# TECHNICAL SERVICE BULLETIN

Technical Service Bulletin: 502-1397

Forest River is alerting you to an issue involving certain 2021 East to West Tandara Fifth Wheel recreational vehicles. Please see the information below which describes the issue and provides you with details on the steps you should take to have your vehicle repaired.

# TECHNICAL SERVICE BULLETIN 502-1397 REMEDY INSTRUCTIONS

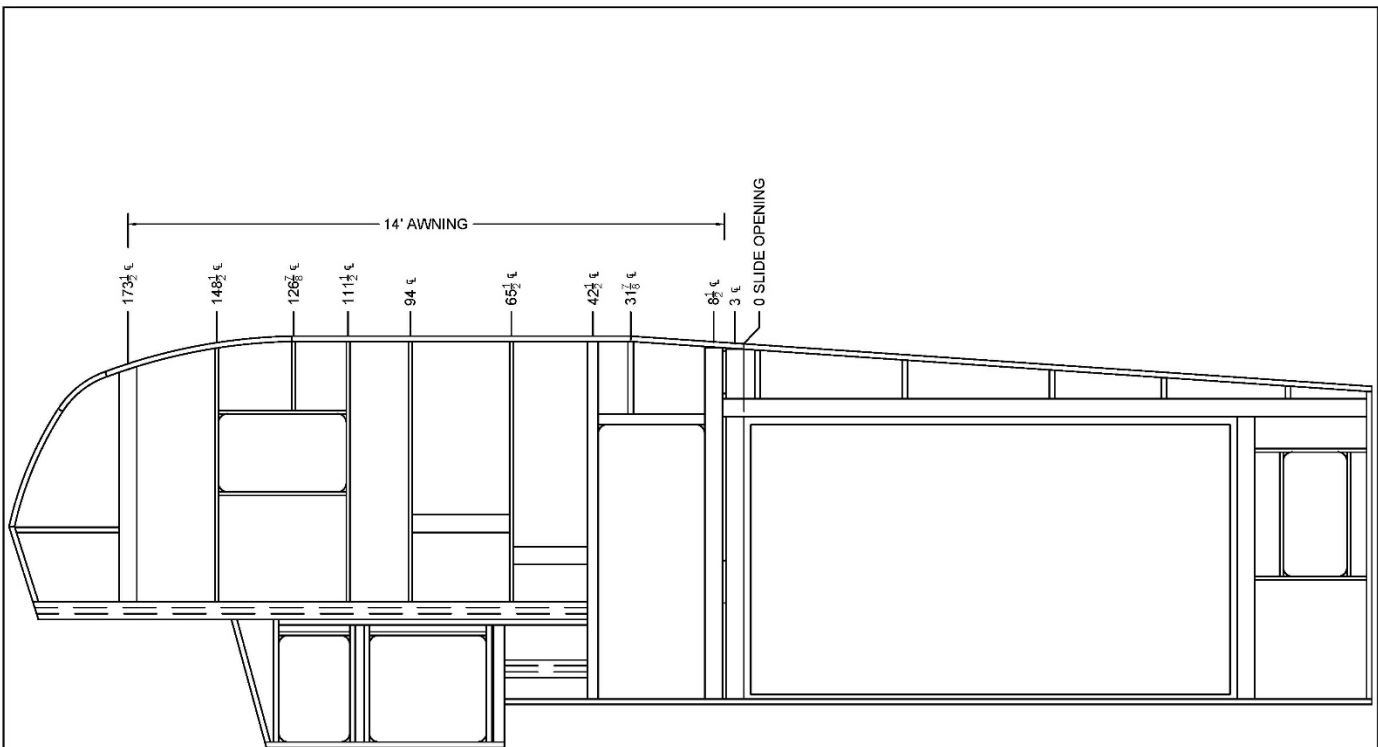
Concern:  
 The awning rail is not secured properly to a backer in the sidewall.

STEP 1: USING THE INCLUDED DRAWINGS FOR REFERENCE, LOCATE AND INSTALL ADDITIONAL 1" WOOD SCREWS (MAX. LENGTH, NON-SELF TAPPING) IN THE AWNING RAIL. ENSURE EACH FASTENER HITS THE ALUMINUM TUBES IN THE WALL AS DEPICTED;

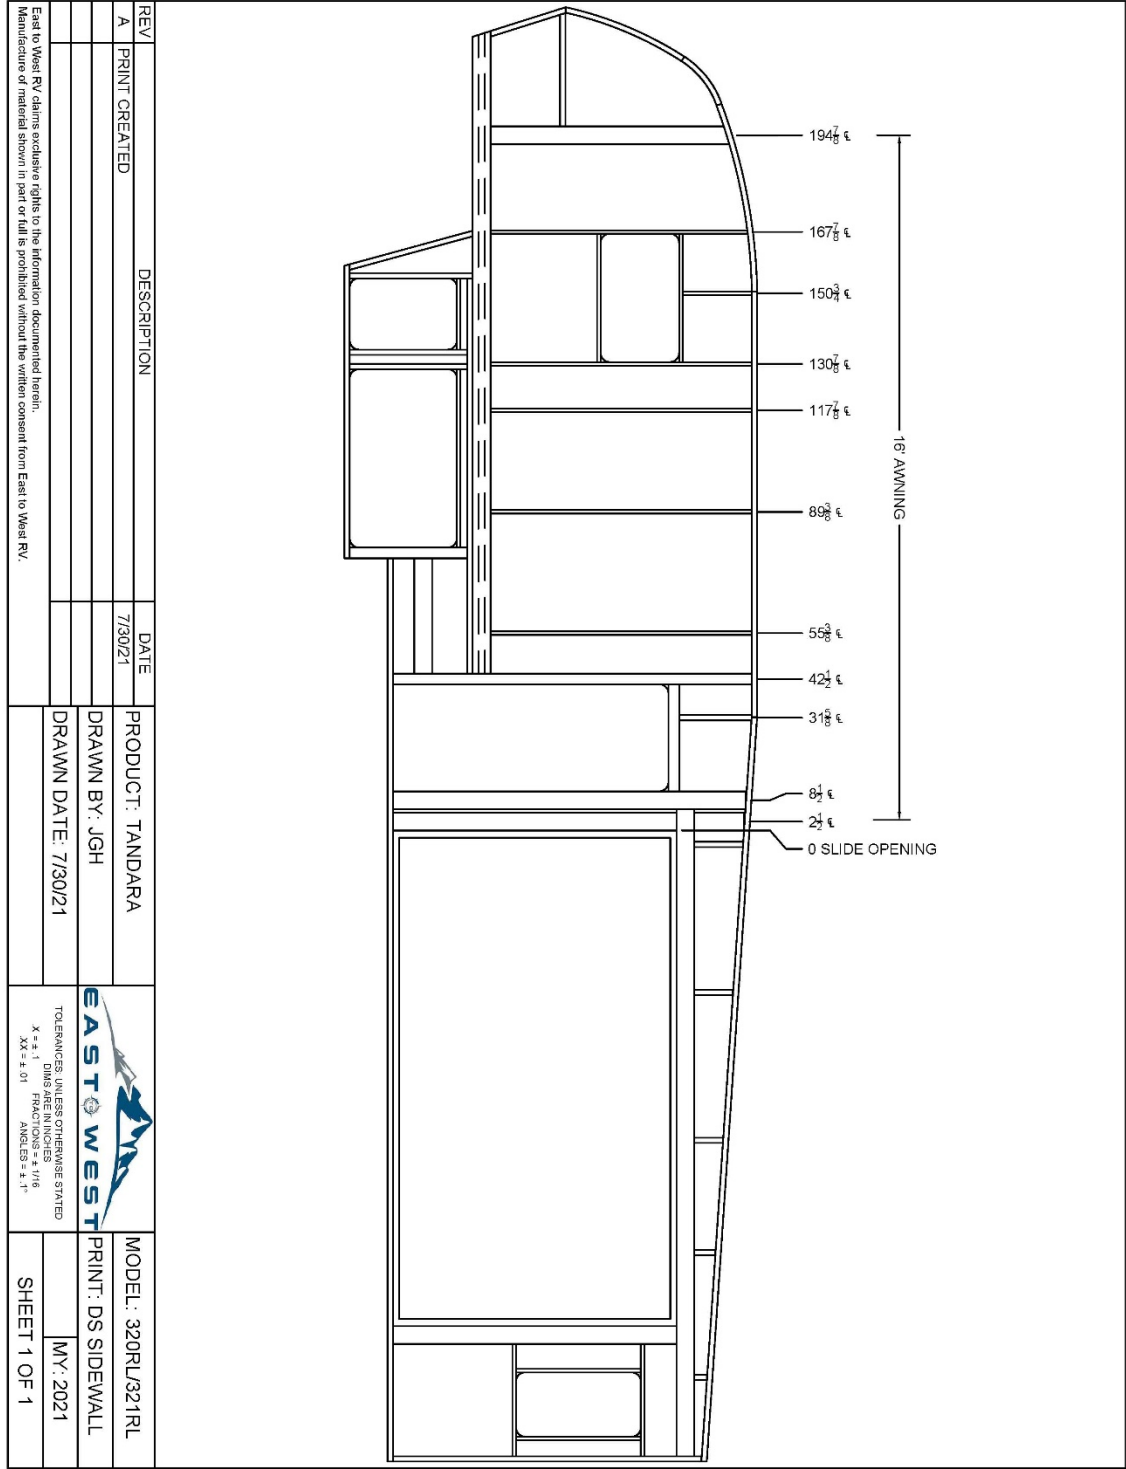
Concern:  
 The awning rail is not secured properly to a backer in the sidewall.

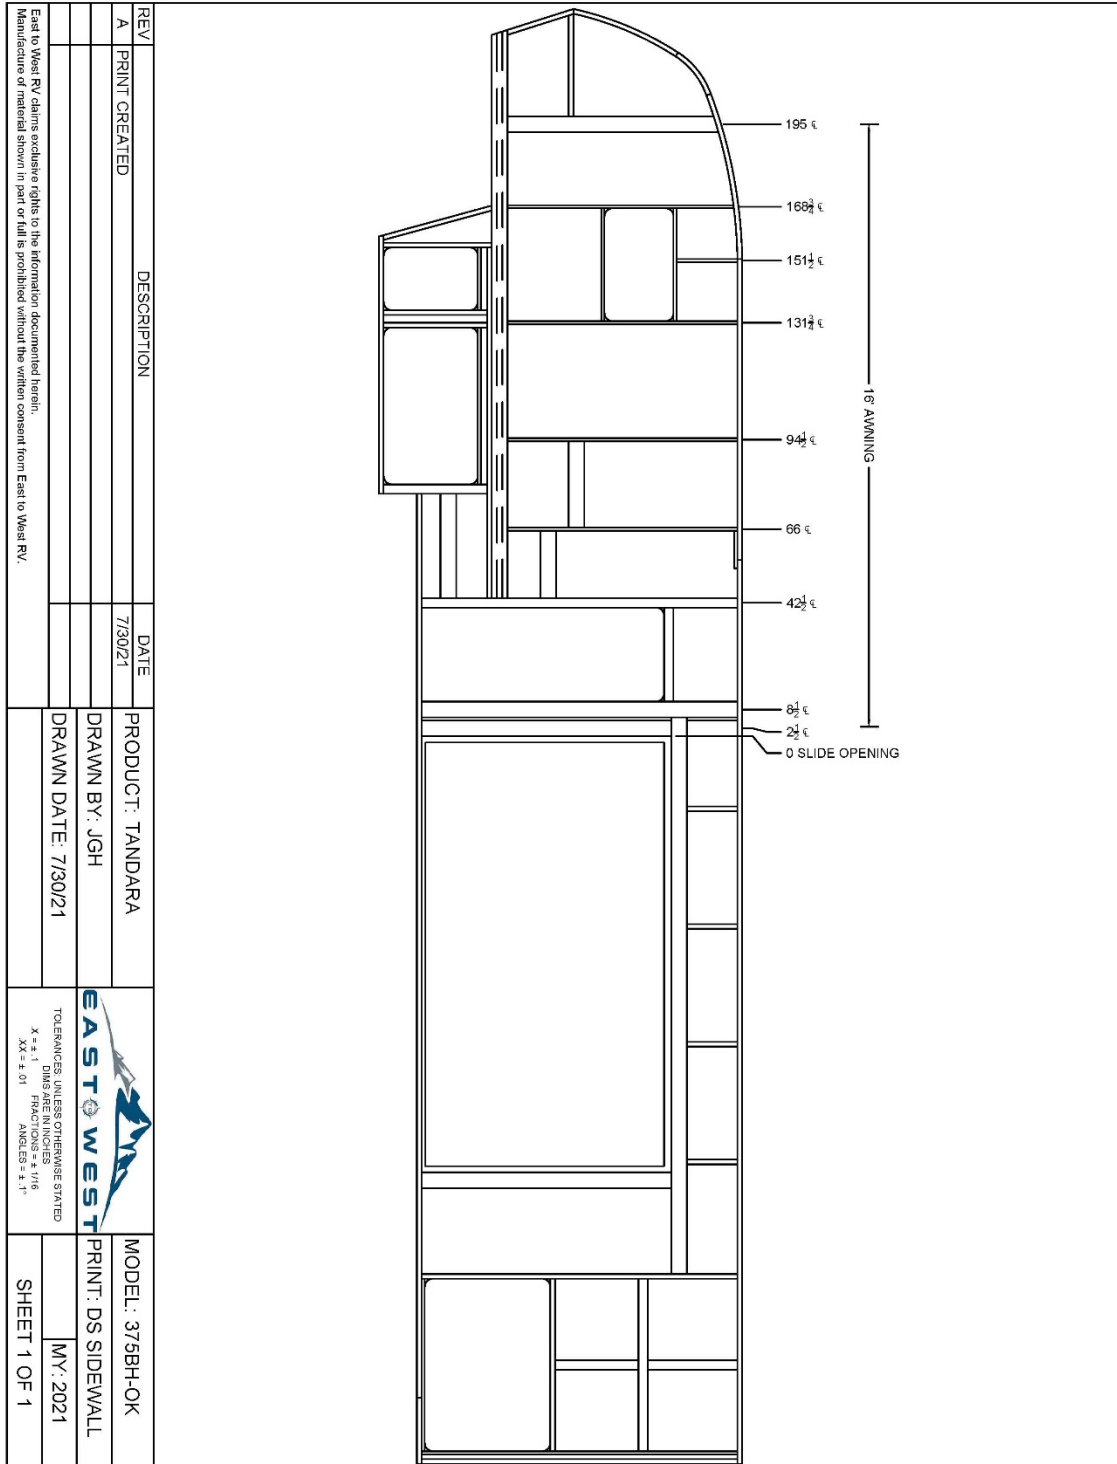
Concern:  
 The awning rail is not secured properly to a backer in the sidewall.
